DOCUMENT NUMBER:	MTN-0054-25
ISSUE DATE:	2025-04

Motorola Solutions Technical Notification (MTN)

Templates created in new web based RadioCentral in a specific date range could have incorrect Trunking Emergency Revert Talkgroup configuration - **Impacts the new web based RadioCentral users only.**

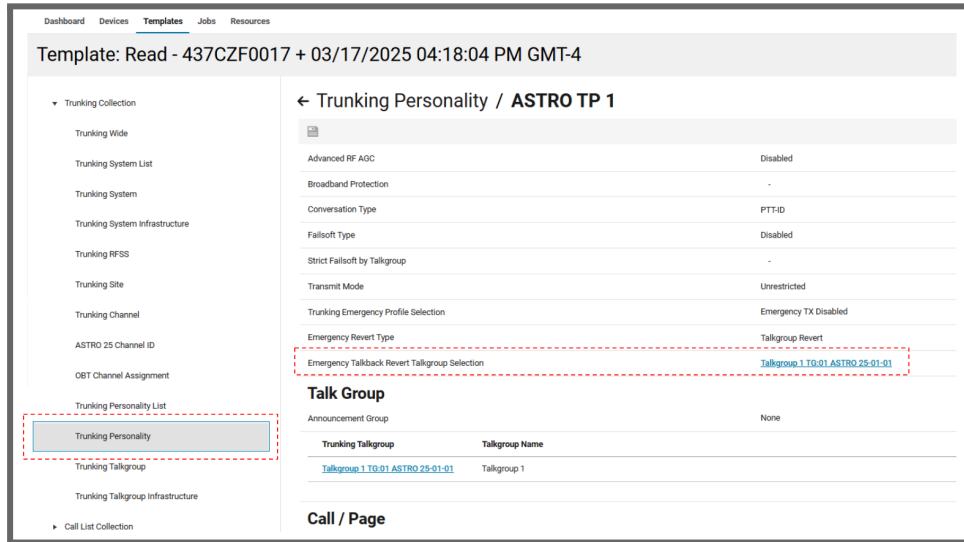
- a. Verify by inspecting the templates in RadioCentral (not using CPS), if the Emergency Talkback Revert Talkgroup Selection in the Trunking Personality is the expected value. A reference screenshot like below:

- b. Make a note for any templates with unexpected values.
- For templates found to be incorrect and in use, please correct the ID to generate a correct new template then assign and write the updated correct template to the devices.
 - For templates found to be incorrect and not in use, you can delete them to avoid accidentally using them in the future.
